MEMORANDUM

Re: Binyomin Amona, dba BAMA Enterprises, Two Lots, each with a Two-Family Home
619 Union Road
SBL# 50.05-1-18

Date: November 26, 2024

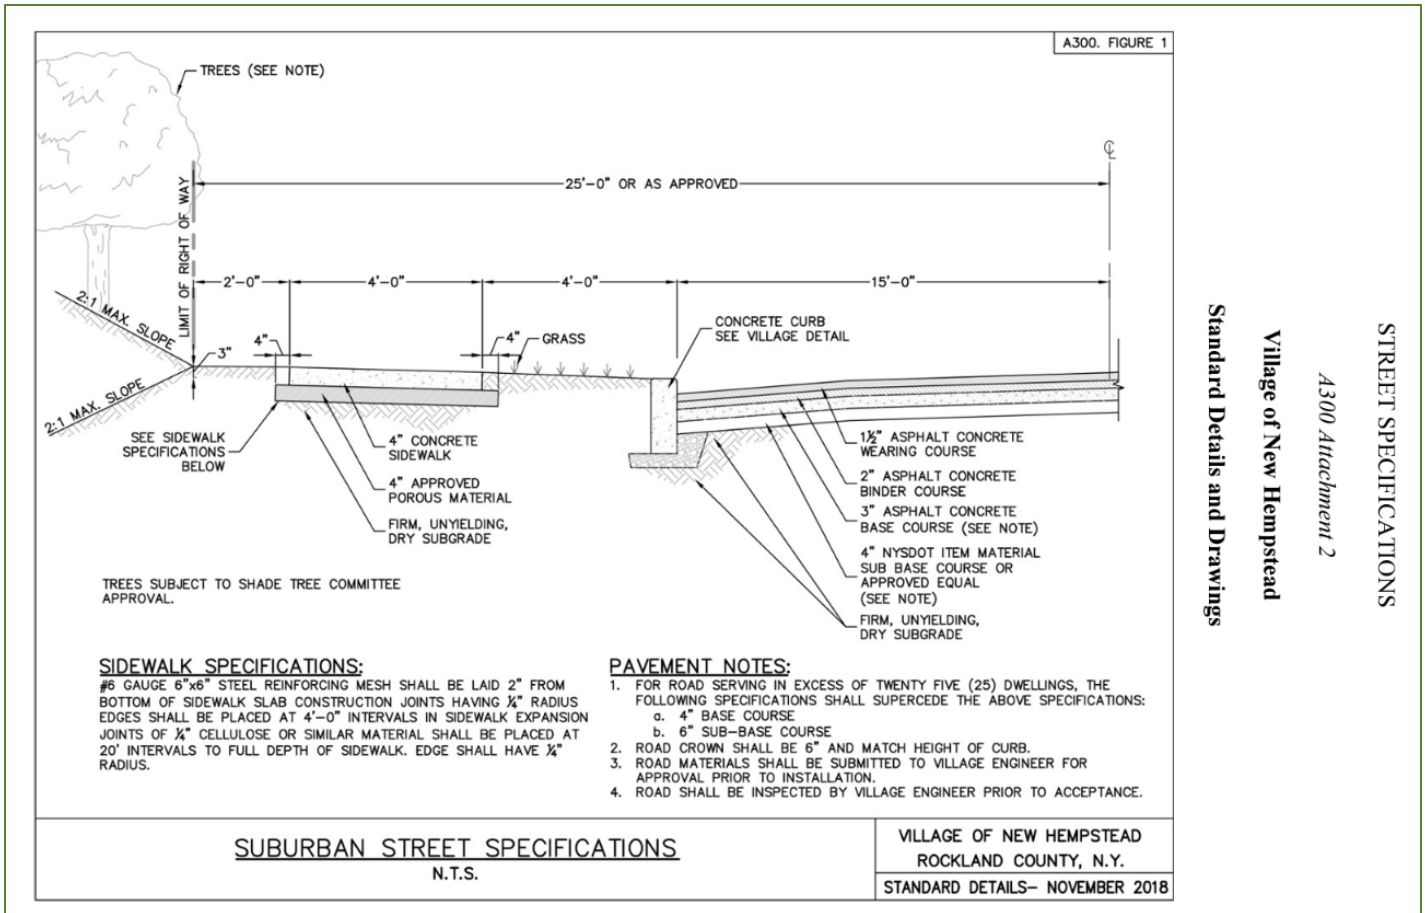
1. **No street frontage is provided for the rear lot.** Per the Table of Dimensional Requirements in §290 Attachment 2, in the 2R-15 District, one hundred twenty-five (125) feet of Frontage on a street meeting Village Standards is required for the rear lot. Only 30 feet of frontage on a right-of-way stub is shown at the southeast corner of the lot. The Table of Dimensional Requirements indicates that variances are needed for lot width and lot frontage for proposed Lot 1, and for lot frontage for proposed Lot 2.

New lots are required to have frontage on either an existing street, or a new street created to Village standards. Rather than providing a new street for Lot 2 to gain frontage, only a driveway is shown straddling the property line between lots 50.05-1-18 and 19. The minimum standards for a Village street in 2R-15 are as follows, per §255-32.H Streets and §A300 Street Specifications:

- a. A 50' foot Right of Way is required. On the sketch plan, 30 feet is shown on Lot 1 and 20 feet is shown on the neighboring lot 50.05-1-19 owned by Binyamin Amona. See §A.300 figure 1, Suburban Street Specification.
- b. Thirty (30) feet of travel way is required, curb to curb, as a minimum pavement width. Only 23.89 feet is shown as the driveway width. The driveway pavement is shown straddling the southern property line, with 11 feet shown on lot 50.05-1-18. See §A.300 figure 1 and §255-31.H for Village road standards.
- c. A cul-de-sac with a 100-foot diameter pavement, within a 120-foot diameter right-of-way is required for this dead-end street. No cul-de-sac is provided. See 255-31.E and H.

A street conforming to Village standards should be designed for this project. If a Village street with a cul-de-sac is created, per footnote 2 of 290 Attachment 2:4, the Table of Dimensional Requirements, the minimum lot frontage on a cul-de-sac may be reduced, but the granting of such a waiver would be at the Planning Board's discretion.

For a street with fifty-foot right-of way and 120-foot diameter cul-de-sac to be created, and then to maintain a minimum of 20,000 square feet for each lot and 125 feet of street frontage, contiguous land owned by the applicant will need to be used. As land is available to the applicant that could and should be included with the application, we would recommend that the Planning Board urge the applicant to include his adjacent lot, and design a conforming layout, as described below.
